RE: NBHS - BG 24-192 - Change Order 24 - Whirlpool Faucet

## Change Order

**PROJECT:** *(Name and address)*  
Phase II Athletics - Bid Package No. 2 -  
NB Field House  
Bullitt County Public Schools

## Change Order Request 40 - PCO #95 - Mobile Whirlpool Tub at Training Room

# Manual Sink Faucets 897-CCP

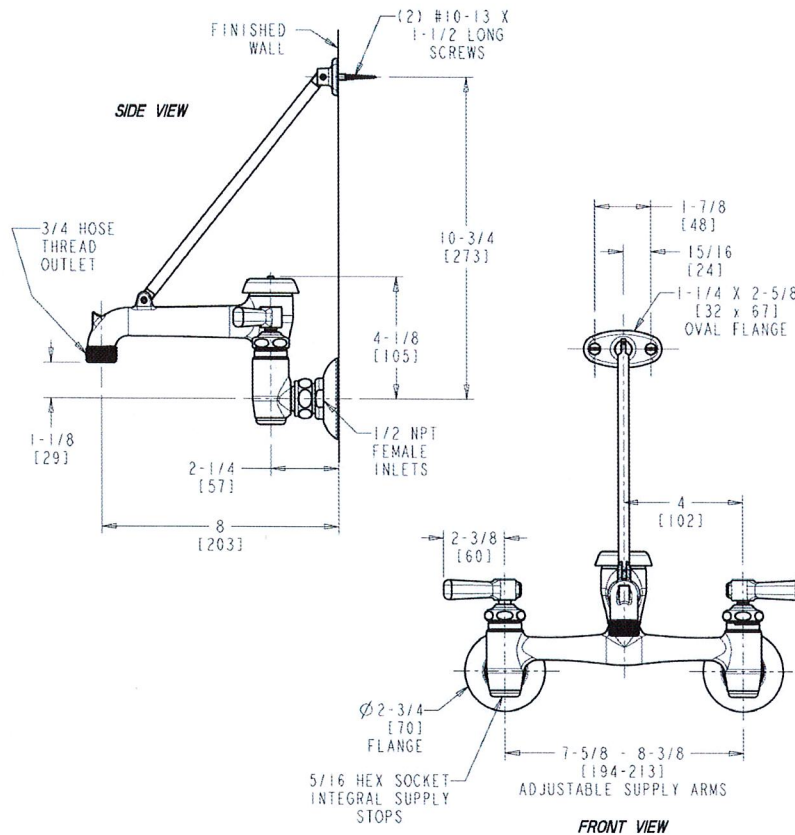
Please find our change order request to add 1 faucet for the whirlpool along with the associated pipe, valves, fittings, hanger and insulation. See attached estimate sheet for clarification.
